Addendum: 1

Date: 08/14/2026

Project: Northwest Allen County Schools
Huntertown Elementary School Mechanical Upgrades

Comm #: 26842

FIRST FLOOR ELECTRICAL DEMOLITION PLANS

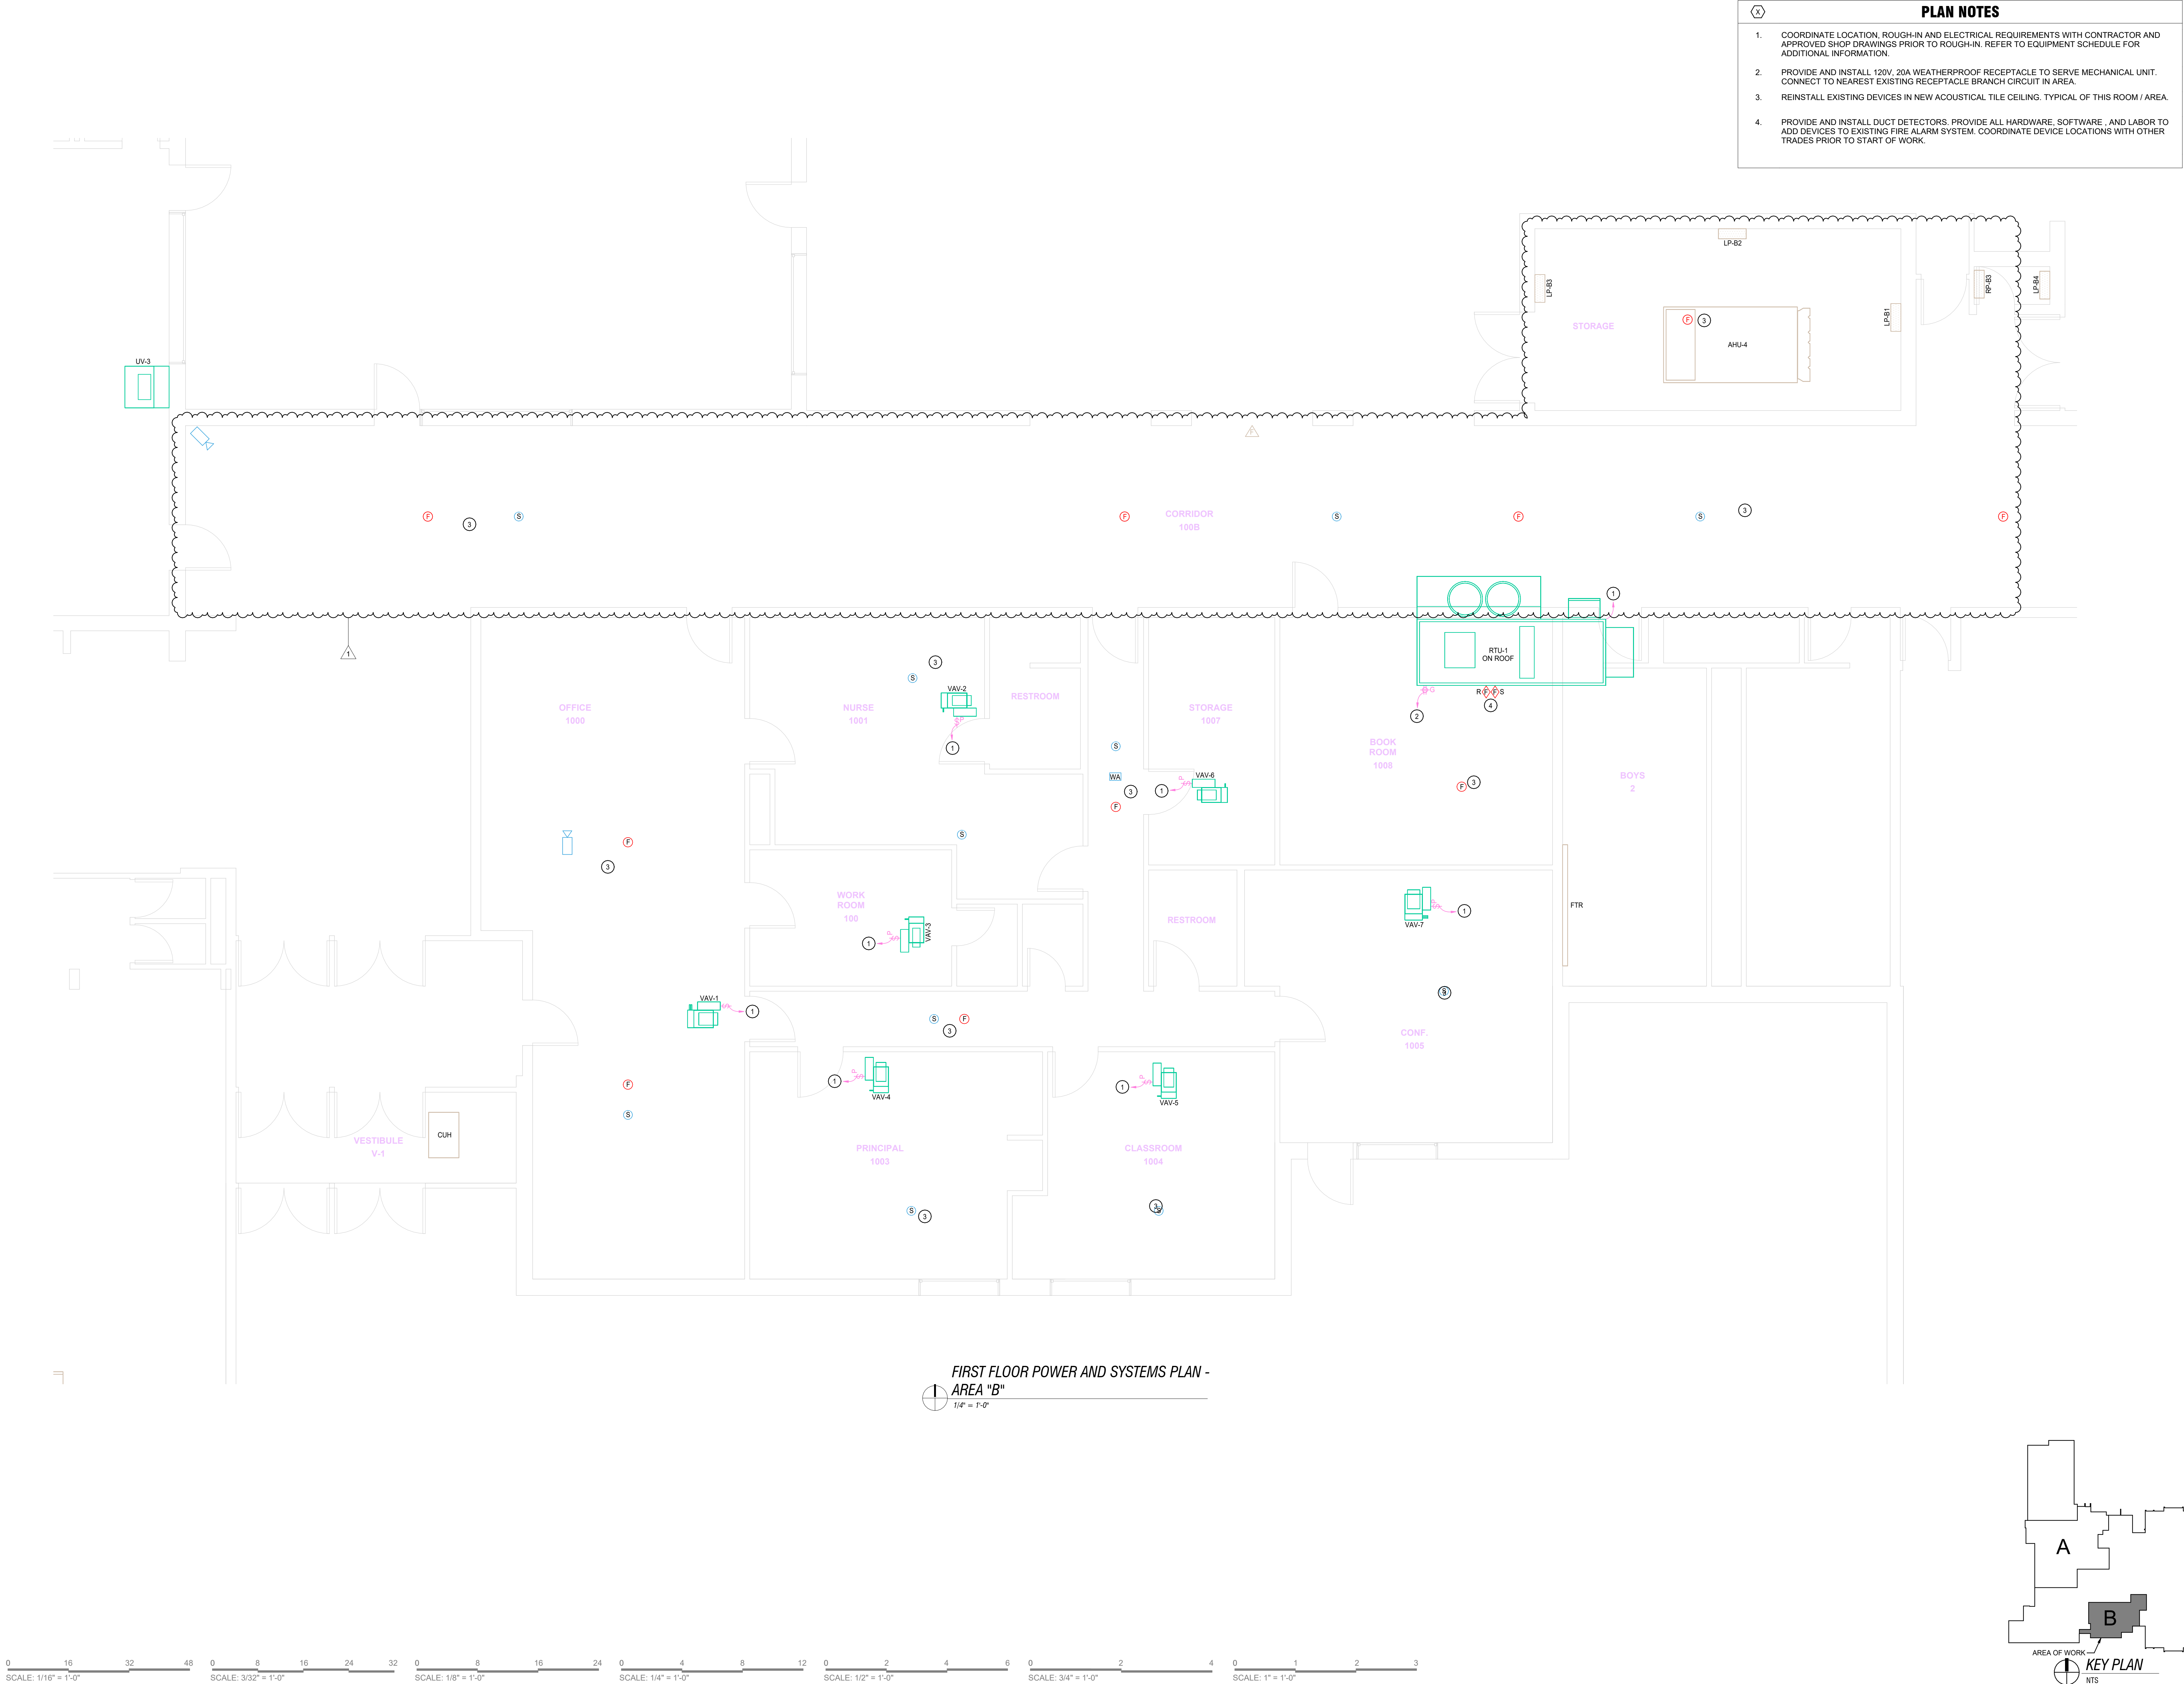
- A. Corridor lighting and ceiling device to be salvaged and reinstalled in new ceiling. Storage Area lighting needs to be removed and prepared for new lighting and controls. Storage ceiling devices to be salvaged and reinstalled in new ceiling. Refer to supplemental sheet for more information.

TITLE:
**FIRST FLOOR
POWER PLANS**

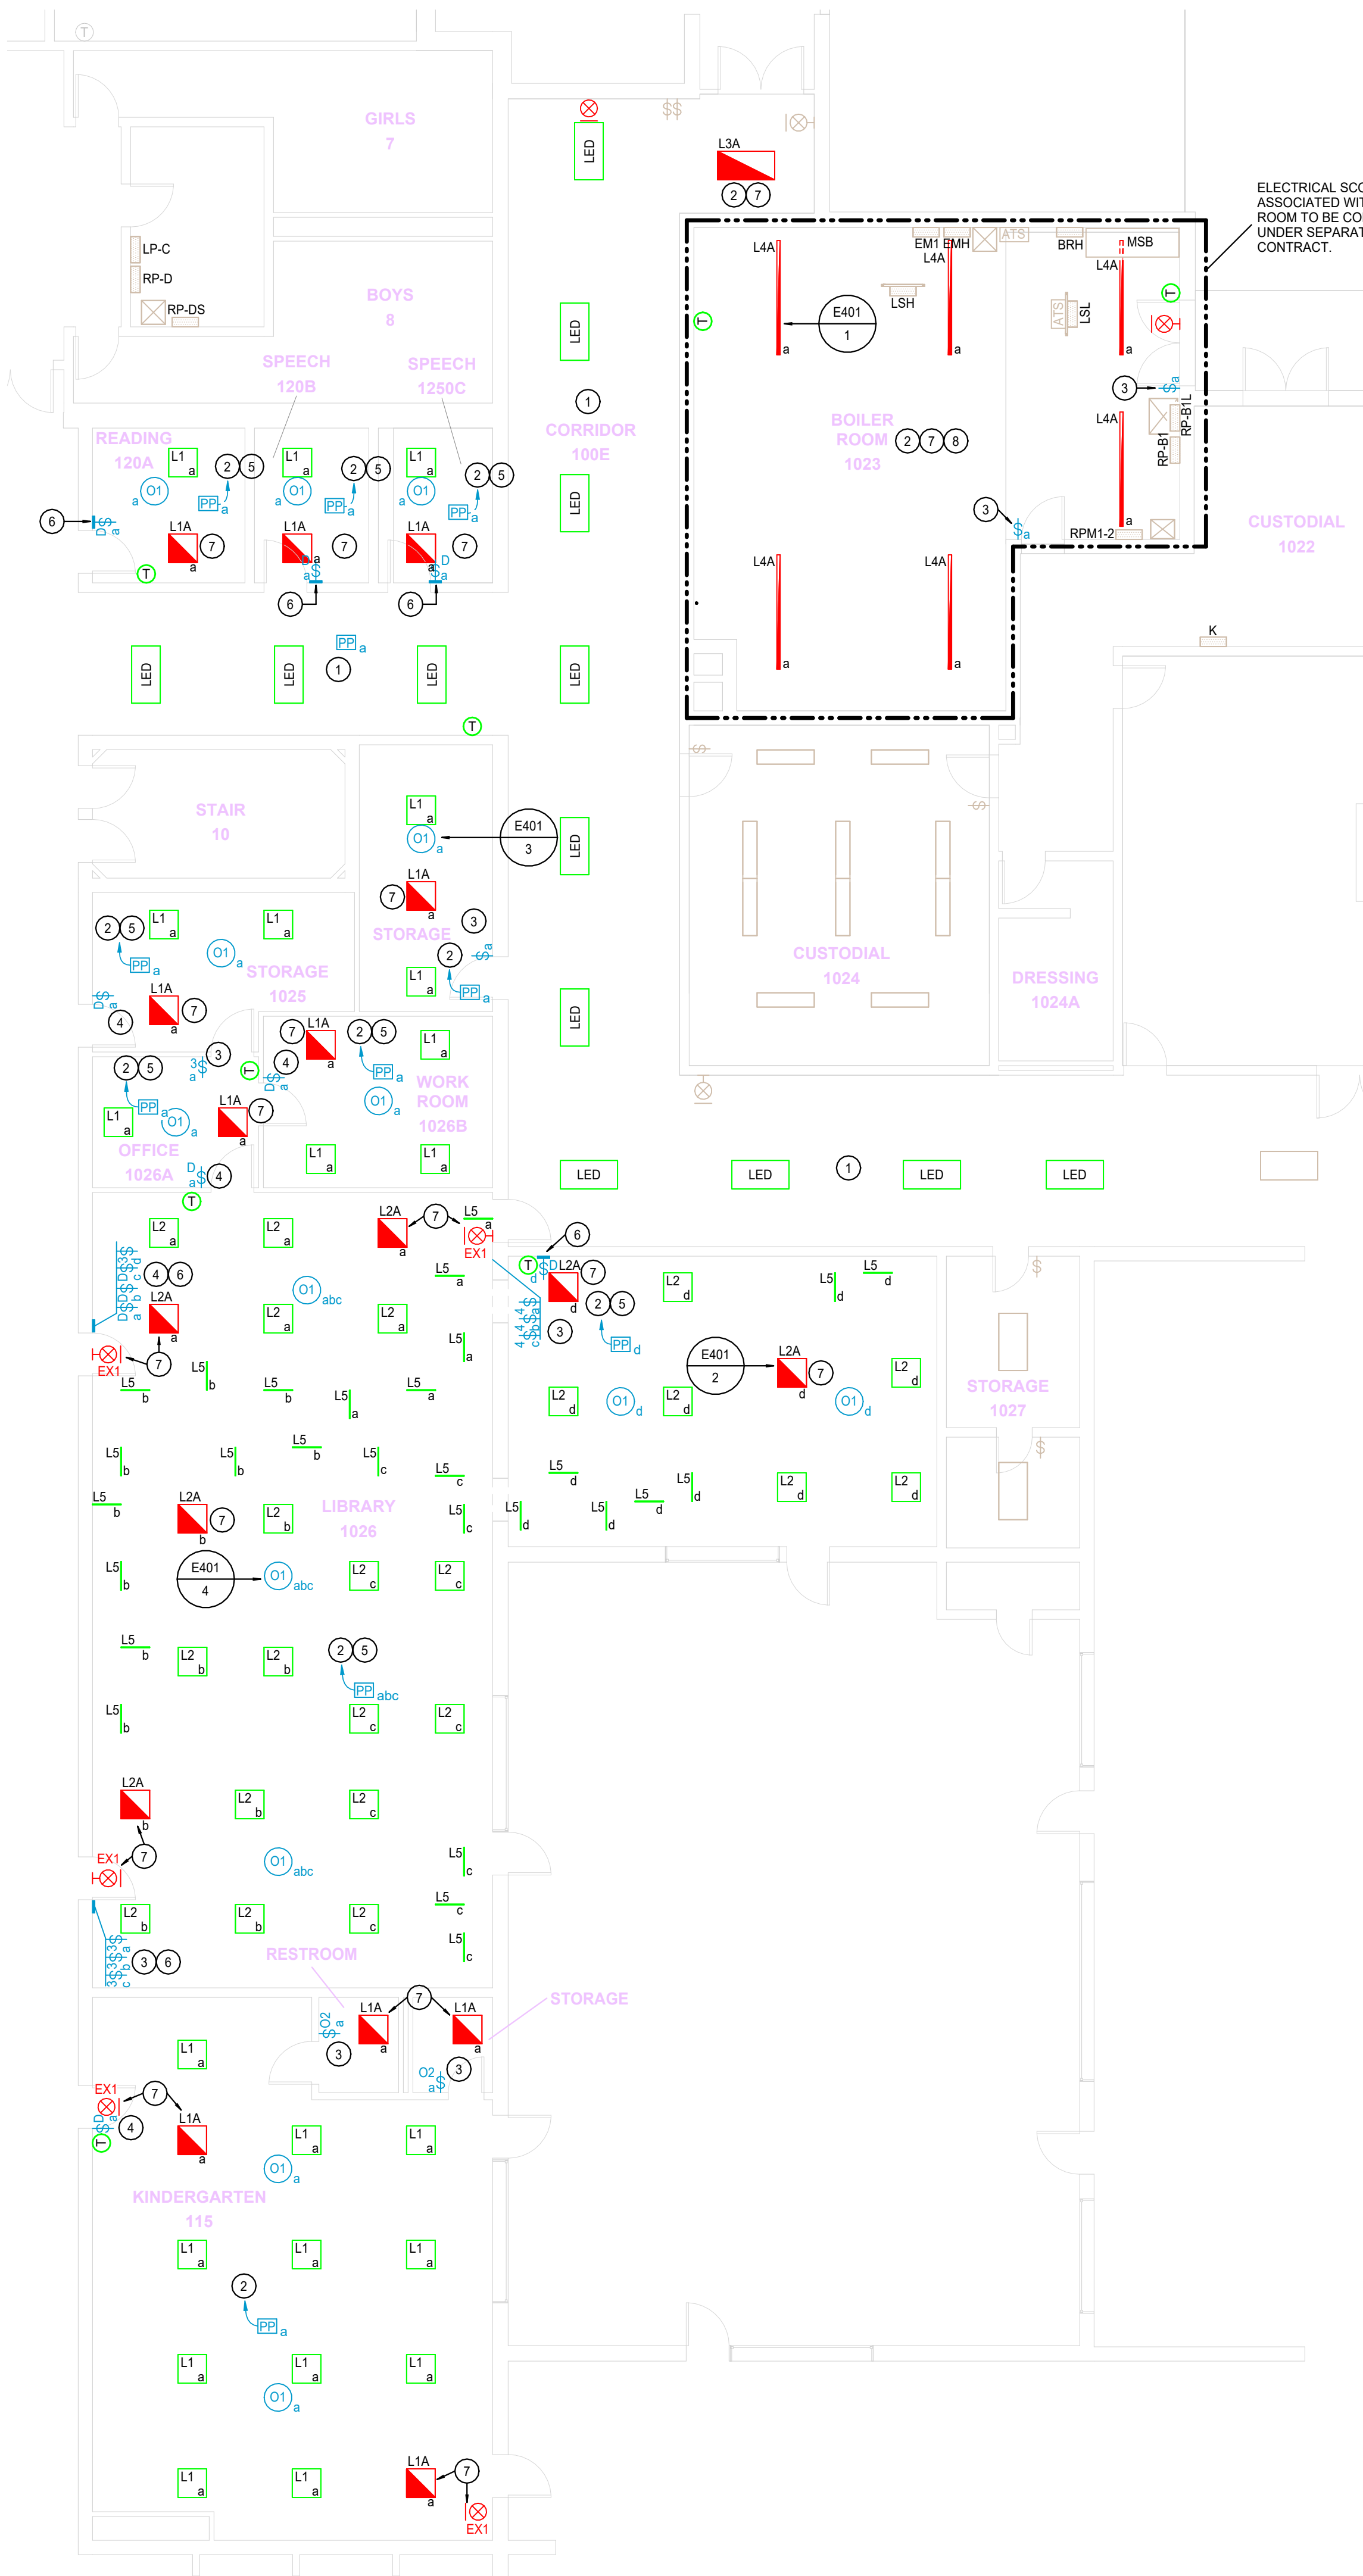
- A. Corridor and Storage ceiling devices to be salvaged and reinstalled in new ceiling. Refer to supplemental sheet for more information.

TITLE:
LIGHTING PLAN

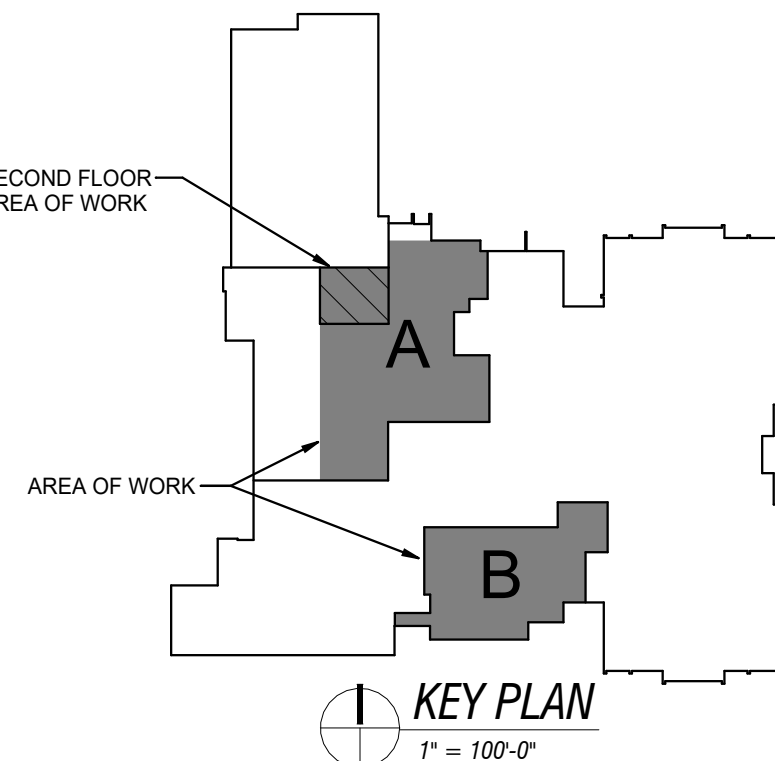
- A. Corridor lighting to be reinstalled in ceiling. New lighting and controls to be installed in Storage area. Refer to supplemental sheet for more information.
